**PLANNED UNIT DEVELOPMENT &
SUBDIVISION STAFF REPORT****Date: October 6, 2005****DEVELOPMENT NAME**

Louise Place Subdivision, Unit 2

APPLICATION NUMBER Holdover DATE October 20, 2005
APPLICANT Louise Place Subdivision, Unit Two
REQUEST Planned Unit Development, Subdivision

SITE PLAN

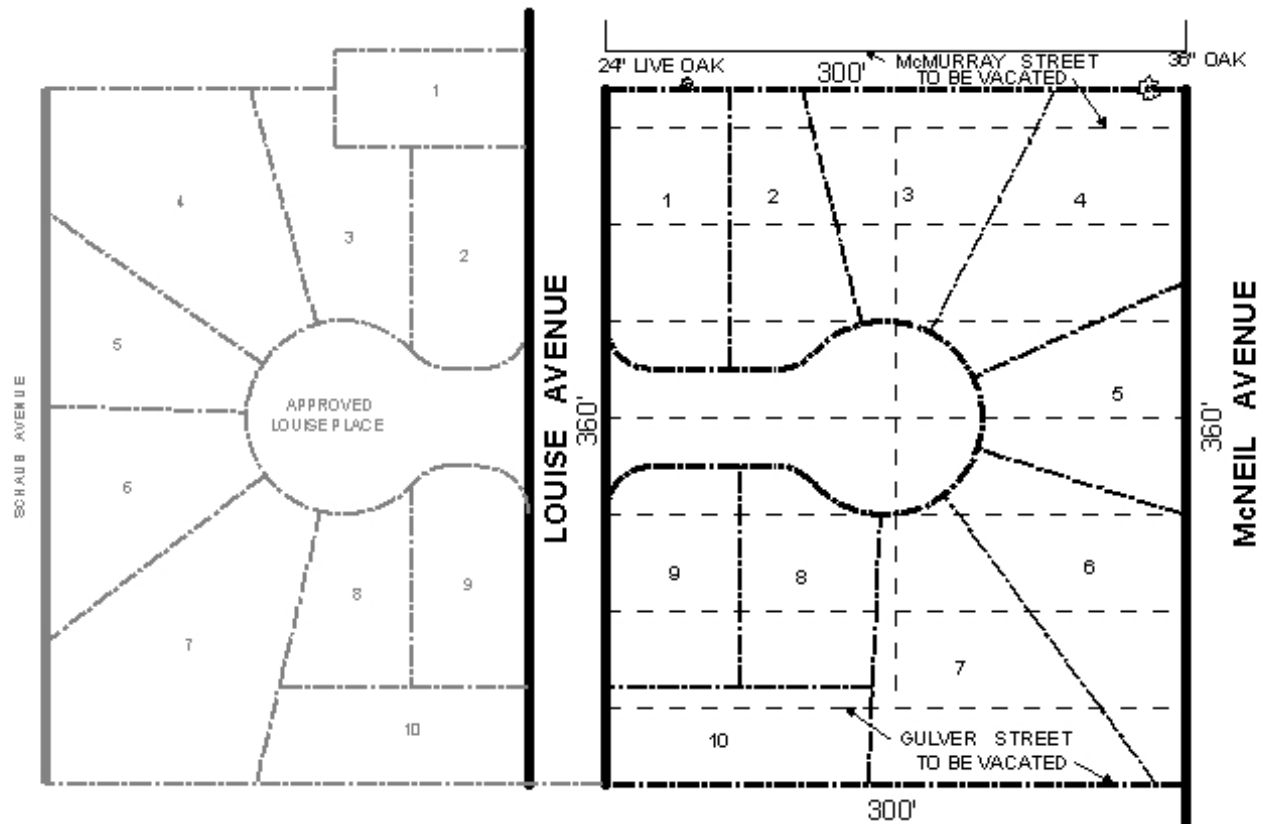
The site fronts Louise Avenue, a 40' unopened right-of-way. This is substandard in width, and dedication of additional right-of-way would normally be required; however, it was not required in the Louise Place, Unit One, application across the street, and thus would not be necessary in this case. Construction of the unimproved portion of Louise Avenue will be required, as will construction of the new cul-de-sac street, prior to signing the final plat; standards of street construction are to be coordinated with and approved by City Engineering. As the site involves several unopened rights-of-way, vacation of such will be required before the plat is recorded or any permits are issued. As a means of access management, proposed Lots 1 and 9 should be denied direct access to Louise Avenue.

Attention should be called to two situations with the proposed site. First, the site plan shows the entirety of Gulver Street being vacated to the proposed subdivision; however, half of the vacated right-of-way should be conferred to the southern neighbors. If the southern neighbors do not transfer their portion of the right-of-way to the applicant, this would leave proposed Lot 10 with only 30 feet of width, which would be unacceptable.

Thus, if the applicant is unable to acquire the southern half of the vacated Gulver Street right-of-way, the plat should be reconfigured to eliminate proposed Lot 10.

The second issue is the shape of proposed Lot 2, which is wide along the street frontage and narrows toward the rear, where it is 37 feet wide. This is atypical of lots on any cul-de-sac, which typically start narrow and widen toward the rear, and of this neighborhood in particular. To satisfy Section V.D.1 of the Subdivision Regulations, which states “*the shape [of lots]... shall be appropriate to the location of the subdivision*”, the side lot lines should either be approximately parallel, or should widen toward the rear of the lot, or the applicant should demonstrate a physical reason for the atypical shape. Proposed Lot 3 to the east, at approximately 9800 square feet, would not be harmed by such an adjustment.

Based on the preceding, this application is recommended for Holdover, to allow the applicant to submit revised drawings depicting a common area with adequate detention; and to revise the configuration of proposed Lot 2 so that the rear is not appreciably narrower than the front.
